**HUGHES
SERVICE INFORMATION
NOTICE**

NOTICE NO. N-103

**SUBJECT: UNIVERSITY SOUND SYSTEM KIT INSTALLATION, PN 269A4190-1/-3;
MODIFICATION OF MA-500 AMPLIFIER**

**MODELS AFFECTED: All Model 269B and 269C Helicopters equipped with ATI
and/or University Sound & Siren System (24/28 Vdc)**

Figure 1. Modification of MA-500 Amplifier

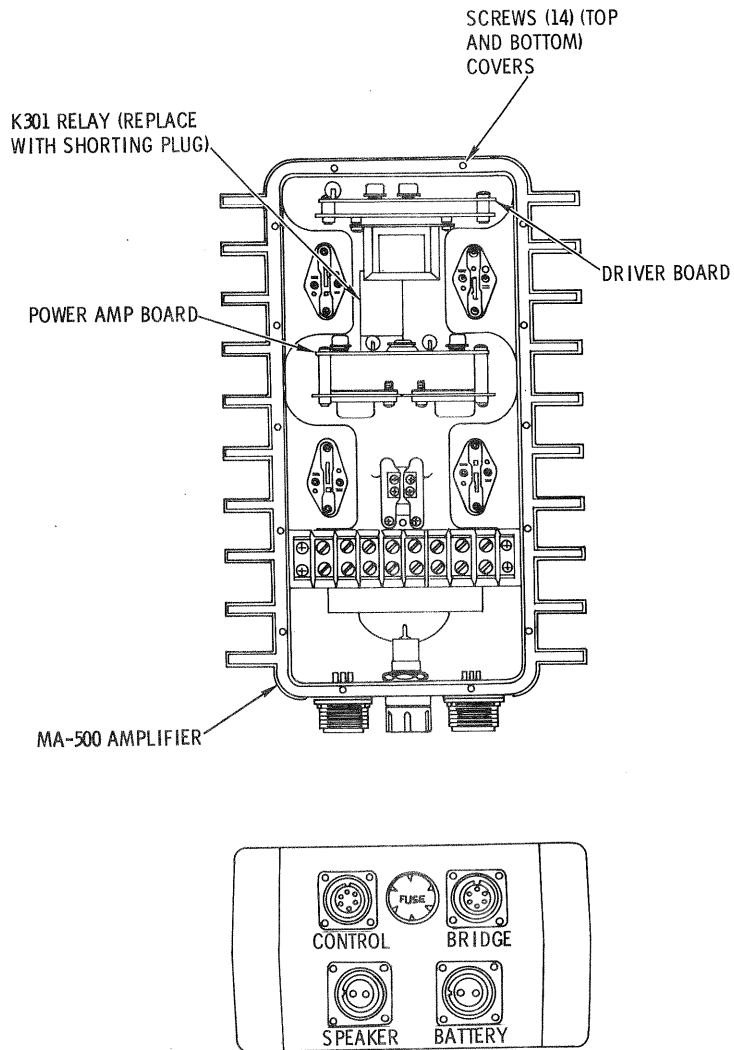
PREFACE: The information given in this Service Information Notice lists a procedure for modifying the MA-500 amplifier incorporated in the subject University Sound System (24/28 Vdc), by replacing the existing PN 72A475 relay with a shorting plug. The modification is designed to improve the operating reliability of the amplifier and sound system installation.

It is noted that removal of the K301 relay eliminates the automatic switching circuitry and voltage sensing capability (12 or 24 Vdc) of the amplifier and control units.

- c. Disconnect and remove MA-500 amplifier unit from helicopter cabin floor underside.
- d. Remove 14 screws securing upper cover and gasket to amplifier housing; remove upper cover. Remove 14 screws securing outer edge of lower cover and gasket to amplifier housing (the 6 inner screws need not be removed); do not remove lower cover. (See fig. 1.)

- e. Place amplifier on bench right side up. Carefully lift housing one or two inches from lower cover to gain access to K301 relay. Using needlenose pliers or equivalent, remove spring securing K301 relay to receptacle in housing. Unplug and remove relay from housing.
- f. Using sealing compound, install new shorting plug in receptacle as replacement for relay. Position plug so that pins align; hold or support the power amp board when pressing the shorting plug into the receptacle.
- g. Install decal on smooth surface area on outside of housing.
- h. Install lower cover and gasket on amplifier housing.
- i. Install upper cover and gasket on amplifier housing.
- j. Install and connect amplifier on helicopter; reconnect battery.
- k. Perform operational check of University Sound and Siren System.
- l. Install lower forward fairing.
